**Summit County Planning Commission (SCPC)**

**Meeting Agenda**

Planning Commission  
Preliminary Plan  
**Picton Parkway**  
Springfield Township

## Preliminary Plan: Massillon Road Industrial Park

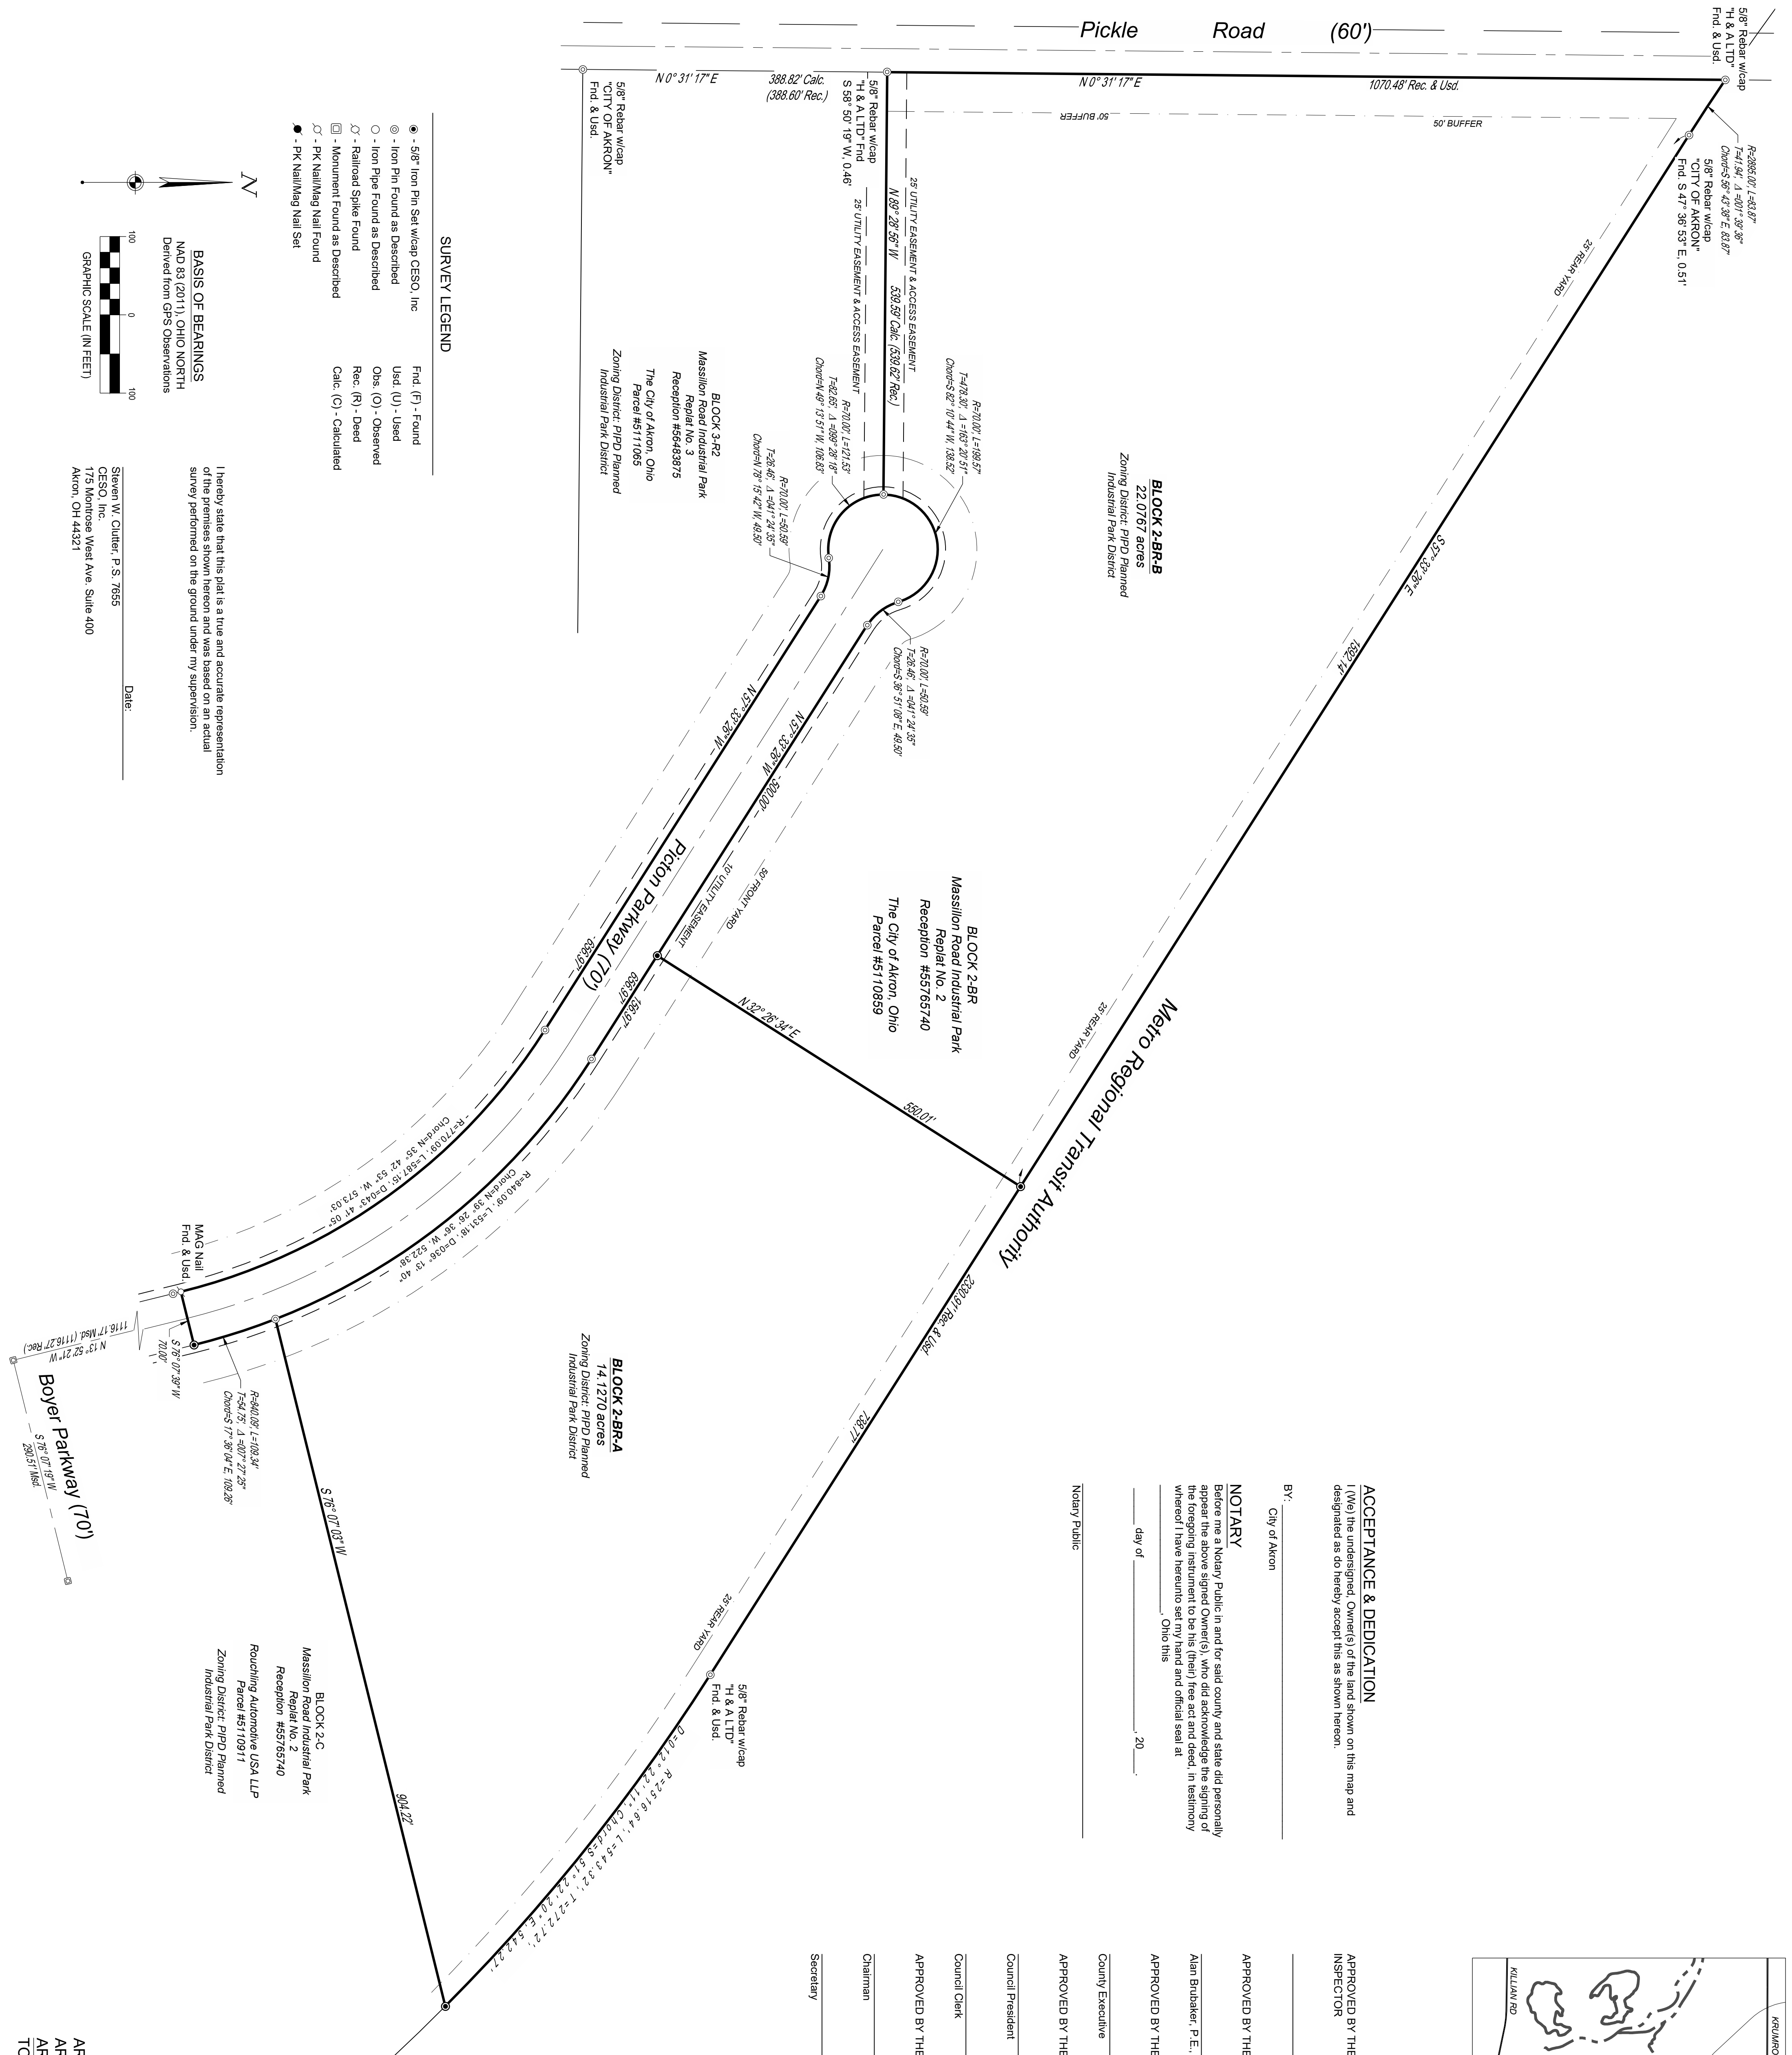
*James Taylor* reported that the applicant is proposing the extension of Picton Parkway project, there were two (2) comments by staff, (1 Soils in the Subdivision shall be identified. (2) Existing ground elevations in the Subdivision: show contours with an interval of two (2) feet.

*Mr. Stoiber* stated the engineering question at hand would be is the temporary cul-de-sac, does that meet the engineer's standards. The second part is the right of way that includes presently, does it have the correct geometry needed for the cul-de-sac?

*Mr. Weinsheimer* also pointed out that when you look at the plat, they have seen another drawing where there have been some property line adjustments on Röchling which what you see depicted on this is different.

*Joe Paradise* stated somewhere halfway in between Schone and the intersection of Boehler and Picton we do not have an overall view of that. This is where Phase I platted the streets stopped and built a temporary cul-de-sac, not sure of the quality of the cul-de-sac or even if this will hold up. Not sure where this is located, in relationship to both the first (1<sup>st</sup>) parcel and second (2<sup>nd</sup>) parcel has not been investigated yet. Not sure if you can have a private drive that blocks off the first (1<sup>st</sup>) parcel and second (2<sup>nd</sup>) parcel because you won't have a public street. This is something that he needs to do a little more research on and will get back to the members. The applicant wants to make it a private street which the County Engineer does not like, as if the property 15-20 years from now, came upon new ownership that wanted to make it a public street, then we may have a problem. This is an issue that they have had numerous times with private streets.

We need to find out by checking the records where the existing cul-de-sac is and how it was built. He did not know this was going to be an issue until 10:00am this day.

*Mr. Paradise* responded, if the cul-de-sac is not extended there will be some easements as there will need to be storm water basins that will need to be accessible for equipment to maintain it.

*Attorney Marvin Evans* had a question about the movement of the property line (the southern property line), is the plan now or is this plat incorrect? Because this question has come up before whether you going to have the land lot parcels if you made this a private road.

*Allen Mavrides* added that he cannot tell as there are three (3) versions of this plat in the records currently, with none of them being the same.

1. The question of if the roadway extension is currently platted as Right of Way has been addressed – it is not recorded as right-of-way currently but this process (preliminary plan then final plat) would have the proposed extension recorded as right-of-way.

- 
2. Will the road extension be public? – “Yes, it will be Public and we spoke to the township (and appeared for preliminary approval on July 11<sup>th</sup>).” Joseph Jorge, 7/17/2024

*Mr. Lott* responded that the plan is that the temporary cul-de-sac would go away once this is built it would need to be extended, that the plan of extending with public right of way.
